Higher Kinnerton Community Council.

LOCATION: Land off Kinnerton Lane, Higher Kinnerton, Chester

PROPOSAL: Erection of 56 No. dwellings with associated access, open space and infrastructure

REFERENCE: 054770

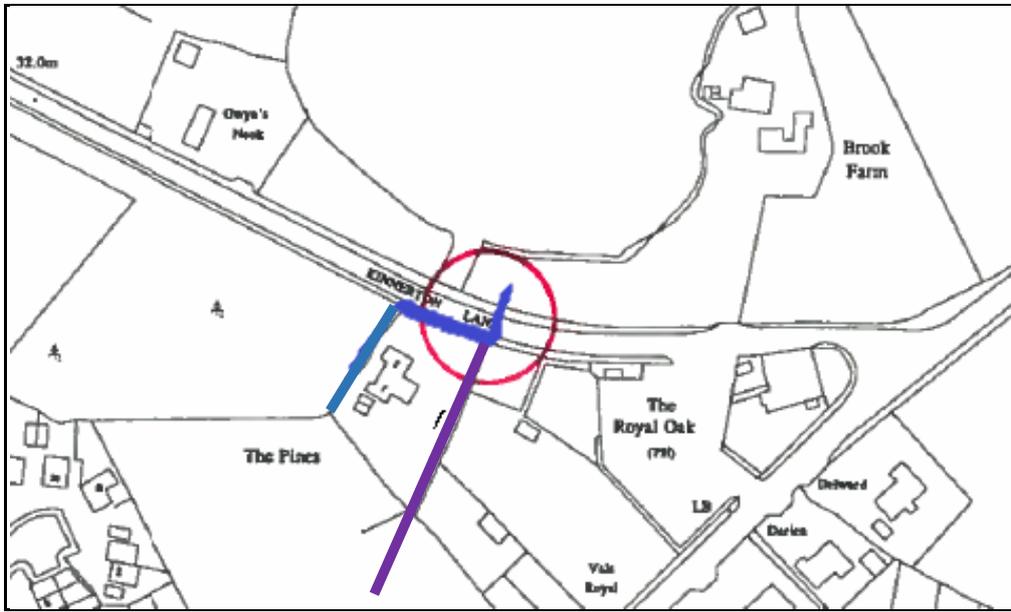
The surface water drainage strategy is the utilisation of natural drainage with storage and percolation areas. The surface water discharge for the development hard paved areas and roof outfalls is via an attenuation system is stated but not fully detailed (HKCC note basic data like connections to roof outfalls are missing on the outline drainage plan). The surface water is then directed to either a new geo-cellular storage system and/or pond (not detailed) and a greenfield percolation area.

The clay substrate detailed in the Ground Investigation Report is generally of low permeability, providing poor natural drainage and is compounded by three natural springs within the confines of the development. This evidence casts doubt upon the surface water drainage strategy from the outset. Controlled flow percolation is therefore not a viable option taking the sub-soil composition, presence of natural springs and the current experience of localised flooding.

Flooding across the proposed development site, despite the installation of land drainage. Note the foreground flooding heading towards the Royal Oak culvert.

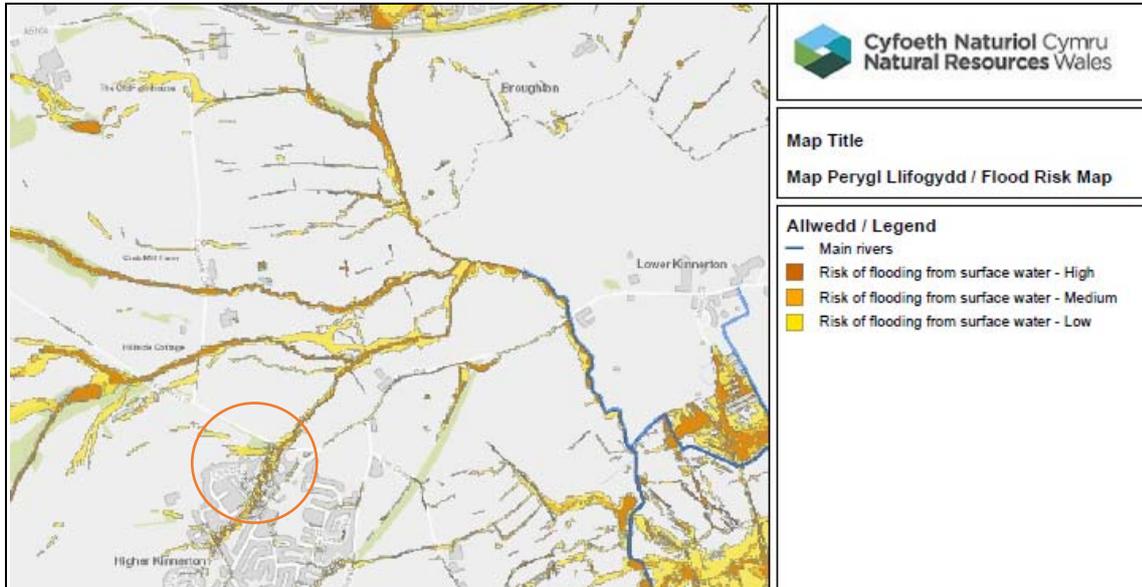
HKCC can only assume an increase in surface water discharge due to the development will add to localised flooding to the culvert on Kinnerton Lane and the surrounding properties/agricultural lands. In recent years Natural Resources Wales have not sought to clear drainage watercourses and this continues to cause flooding issues downstream of the development site. The clay substrate detailed in the Ground Investigation Report is generally of low permeability, providing poor natural drainage is also prevalent to the areas surrounding the development site.

Surface water shown on the cultivated land is unable to percolate into the substrata and is running freely across the development site towards the overloaded Royal Oak culvert.

Castle Cement Water Supply

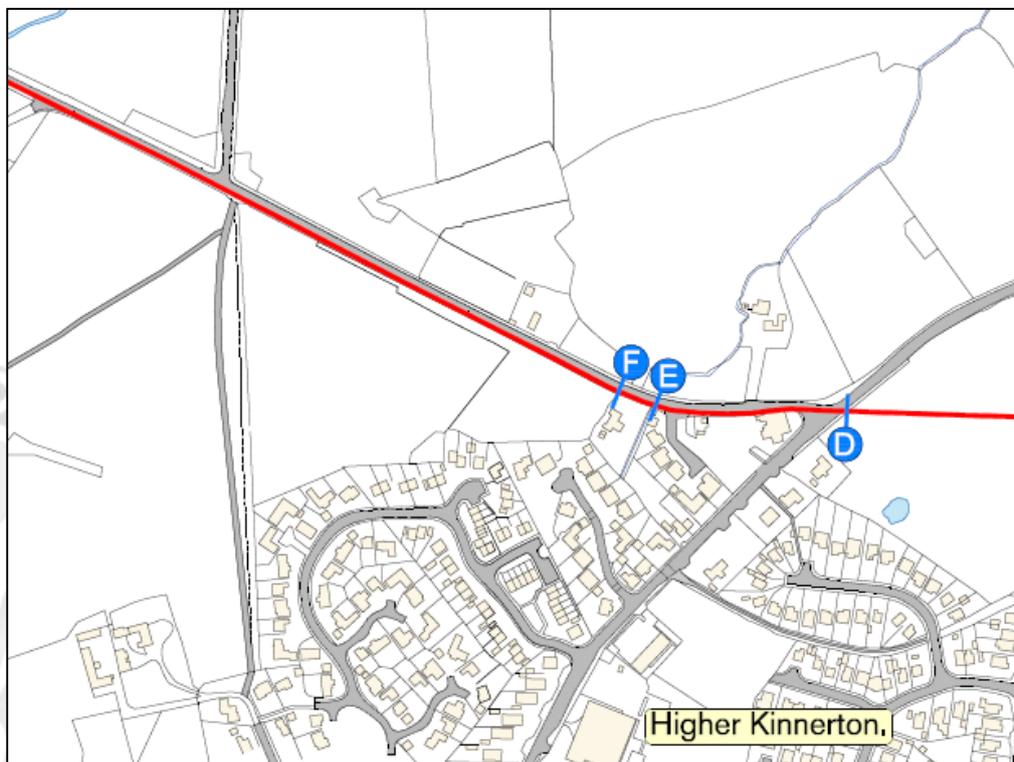
The development plans do not make reference to the water supply infrastructure running along Kinnerton Lane. This pipeline provides water to the Castle Cement facility at Padeswood. It is understood from local knowledge that this water is supplied by several water extraction points within the locality. The pipeline position is on the boundary of the proposed development and will be affected by the proposed pedestrian access should access be required for repair/renewal. The drawing below has been provided by Hanson Group, to which Castle Cement is a subsidiary company. HKCC believe the pipeline is less than 1m below ground directly below the proposed pedestrian access. This is not show on the planning application details.
